# Revision of the EU Green Public Procurement Criteria for Street Lighting and Traffic Signals

**EEB comments on the 1<sup>st</sup> draft of the JRC technical report and GPP criteria proposal**

**20 January 2017**

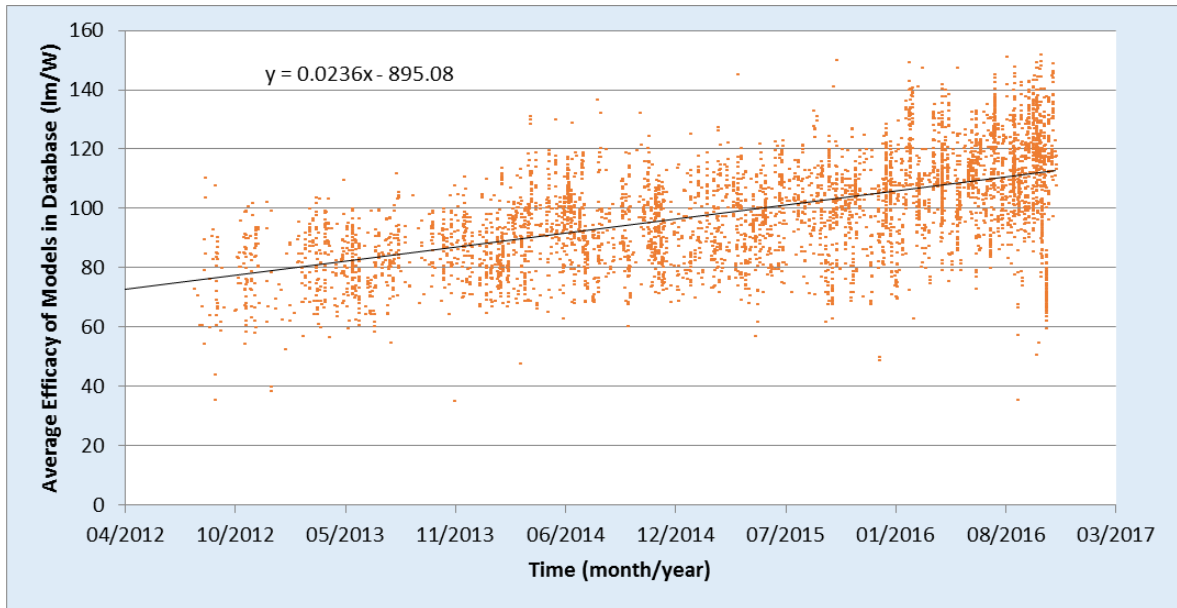
- Tier 2: 1 Jan 2020 – 31 Dec 2021
  - Tier 3: 1 Jan 2022 – 31 Dec 2023
- Having three tiers enables the GPP criteria to follow the technology trend, which we have calculated based on a database of over 5600 street light luminaires from the US DOE's Lighting Facts database, spanning from 2010 to present. We prepared a scatter plot and applied a curve fit to models spanning from 2012 through 2016 finding that efficacy has increased on average of around 8.6 lm/W per year.

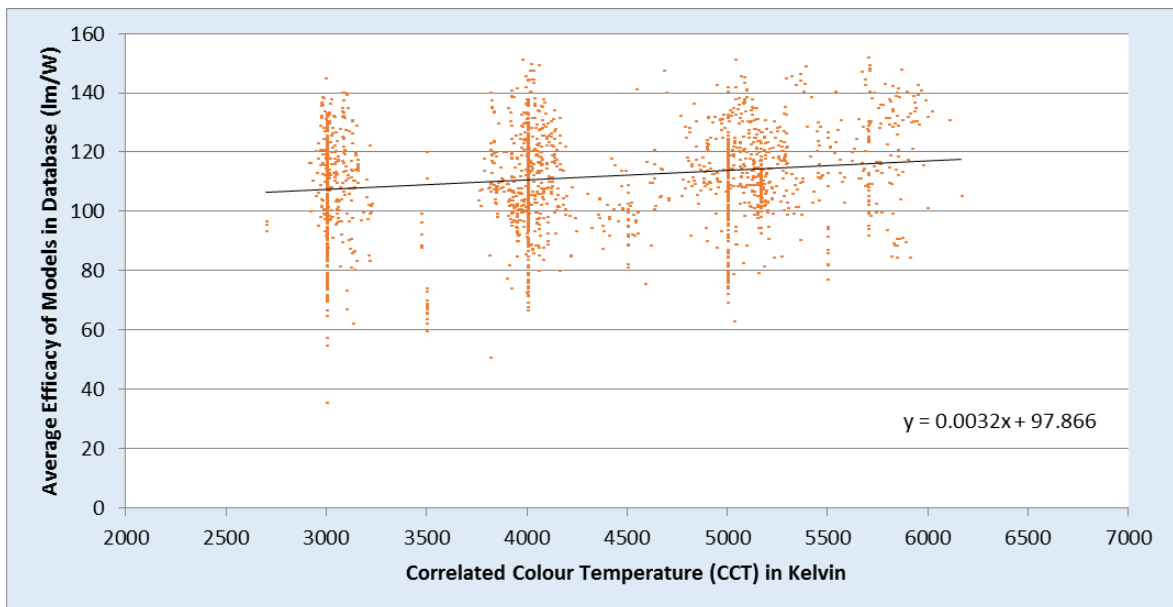
- We have also looked into the link between CCT and efficacy, and we do not consider it to be sufficiently significant to warrant any adjustment to our recommendations above, which is using a complete set (all CCT values) of 2016 models. The figure below shows the slope of efficacy with CCT - essentially, there is an impact of 3 lm/W per 1000 degrees of CCT. Thus, shifting from 5000K to 3000K would only affect the efficacy of the 2016 models by 6 lm/W, thus there is no reason to adjust the values presented in our recommendation above which is derived from a full set of 2016 models in the database.
